STATE OF CONNECTICUT
CONNECTICUT SITING COUNCIL

IN RE: :
: :
APPLICATION OF CELLCO PARTNERSHIP : DOCKET NO. 442
D/B/A VERIZON WIRELESS FOR A :
CERTIFICATE OF ENVIRONMENTAL :
COMPATIBILITY AND PUBLIC NEED FOR :
THE CONSTRUCTION, MAINTENANCE :
AND OPERATION OF A WIRELESS :
TELECOMMUNICATIONS FACILITY AT :
284 NEW CANAAN AVENUE, NORWALK, :
CONNECTICUT : JANUARY 11, 2023

**RESPONSES OF CELLCO PARTNERSHIP D/B/A VERIZON WIRELESS
TO CONNECTICUT SITING COUNCIL D&M PLAN INTERROGATORIES**

On December 28, 2022, the Connecticut Siting Council (“Council”) issued D&M Plan Interrogatories to Cellco Partnership d/b/a Verizon Wireless (“Cellco”), relating to Docket No. 442. Below are Cellco’s responses.

SHEET NUMBER
GN-1

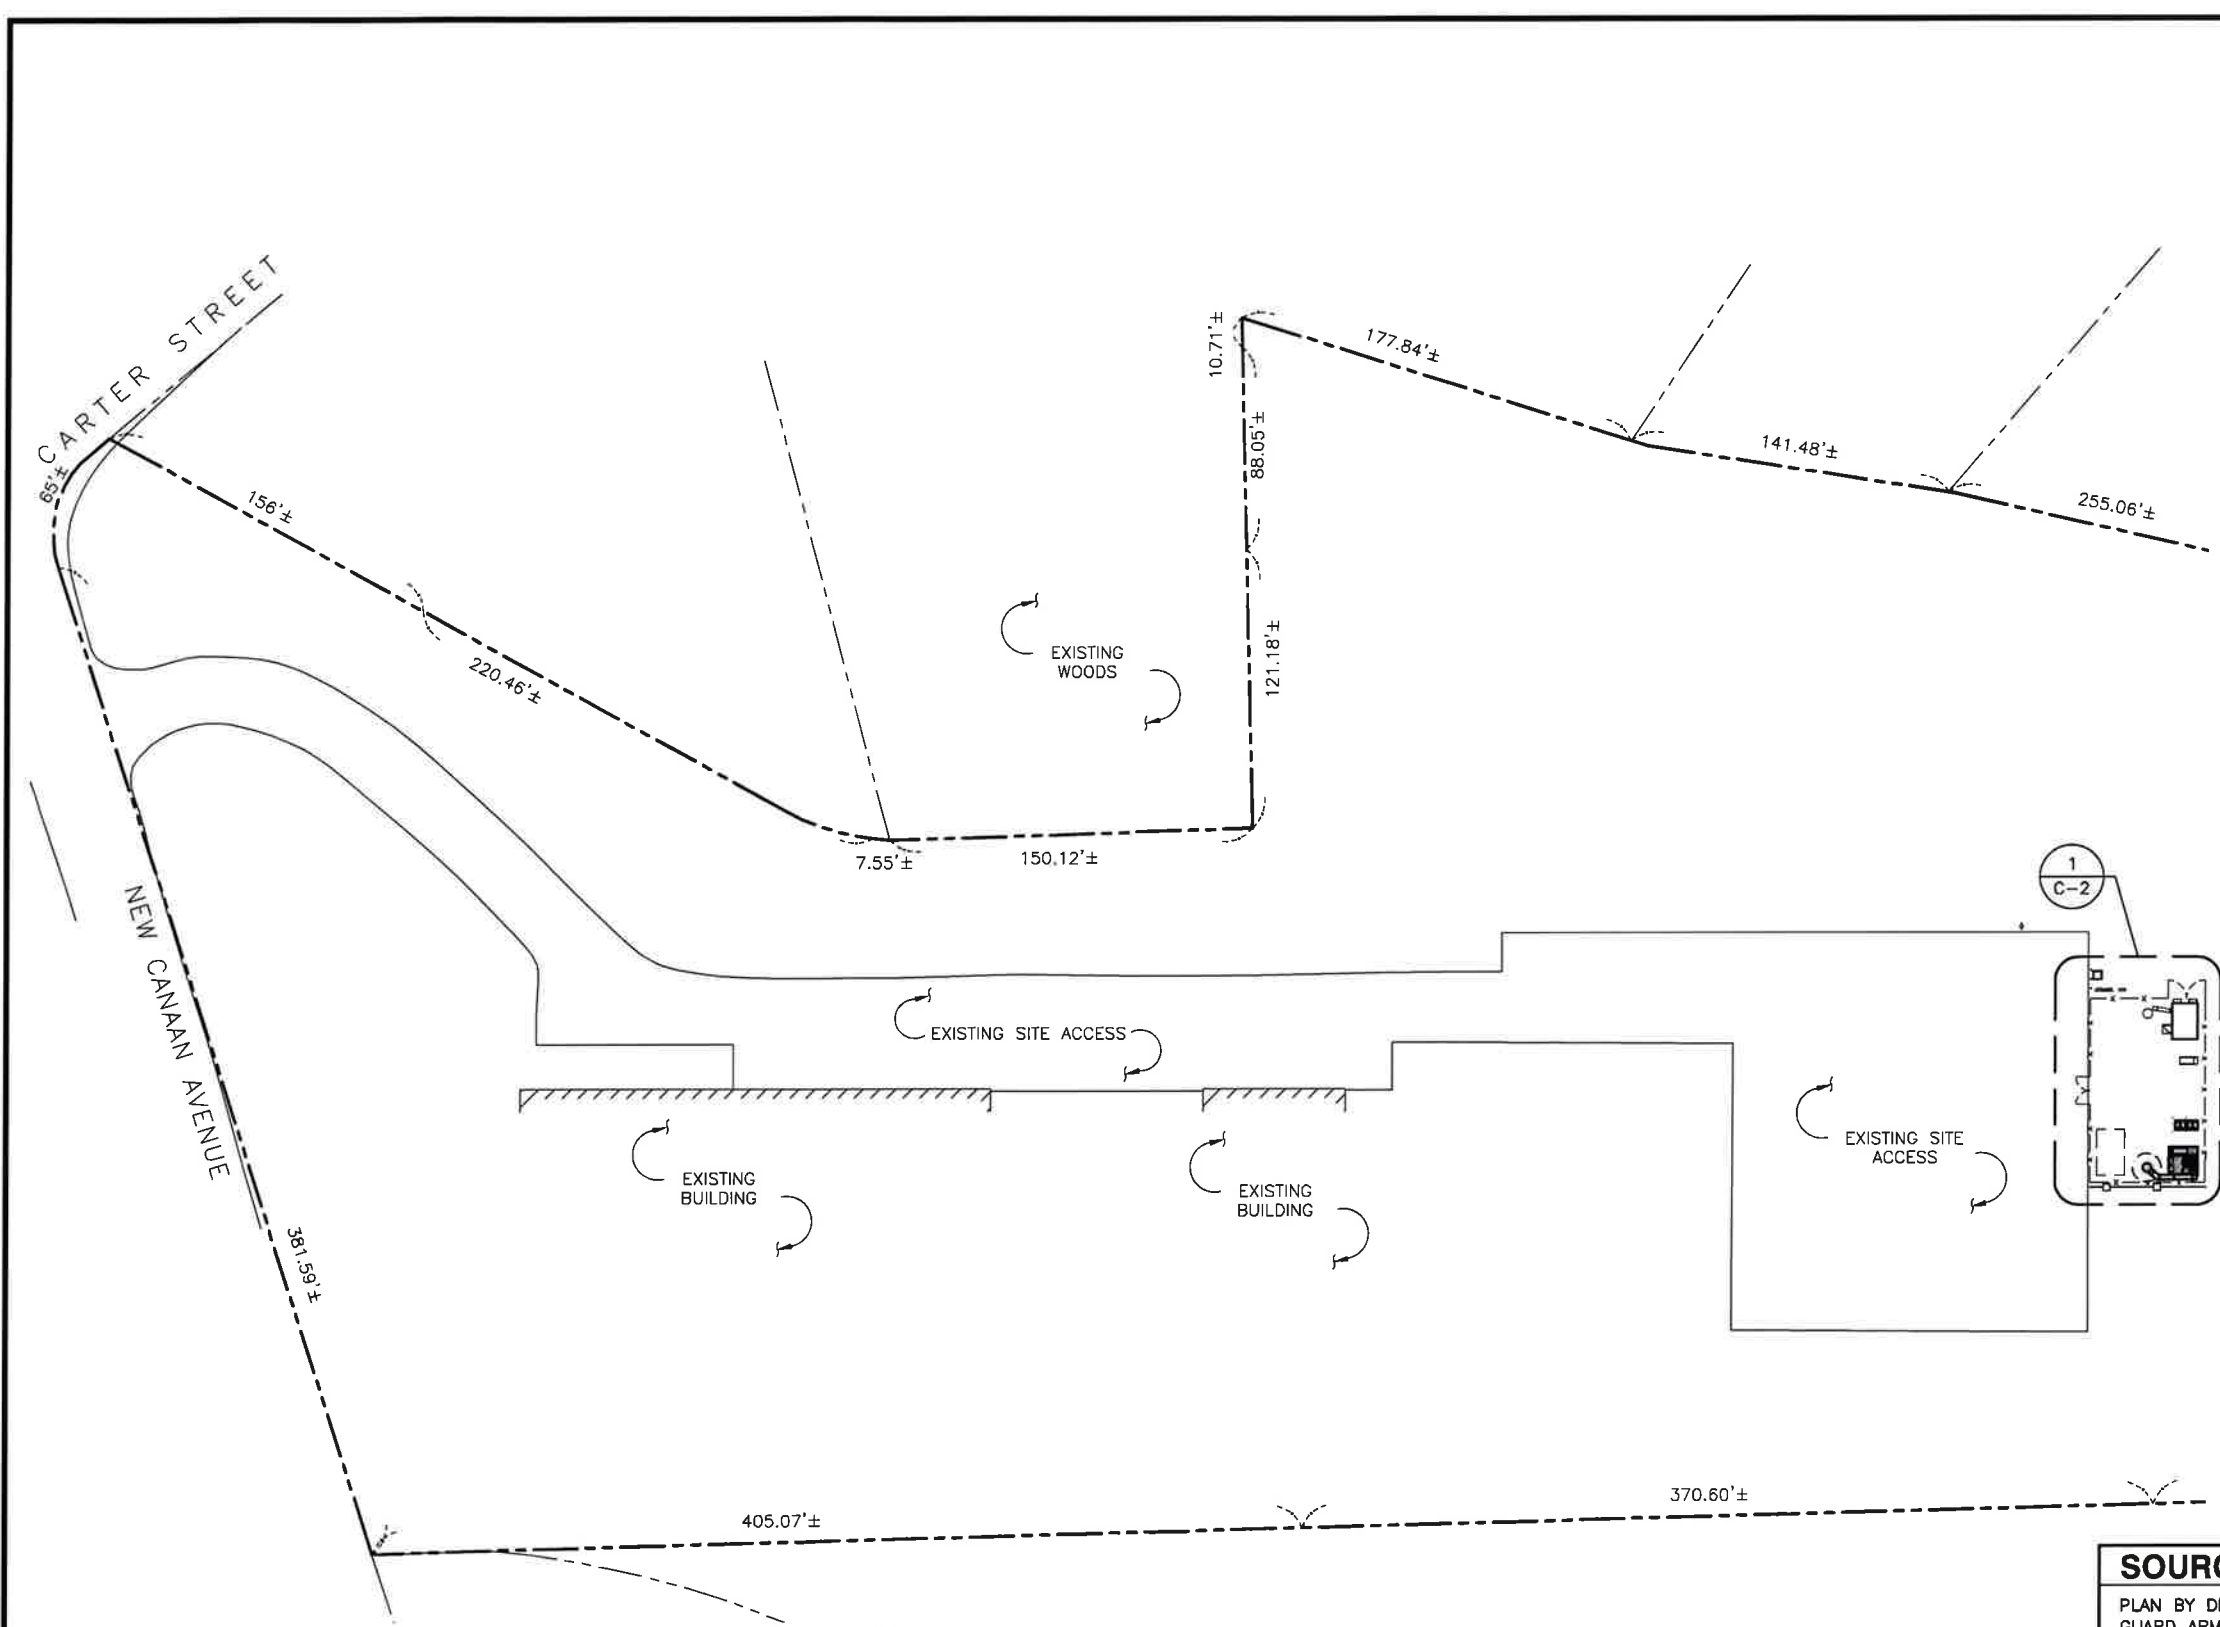
Site Plans GN-1 and SN-1 refer to EIA/TIA-222-G. Revise the drawings to include reference to EIA/TIA-222-H.

See Attachment 1 – Revised D&M Plans, Sheets GN-1 and SN-1.
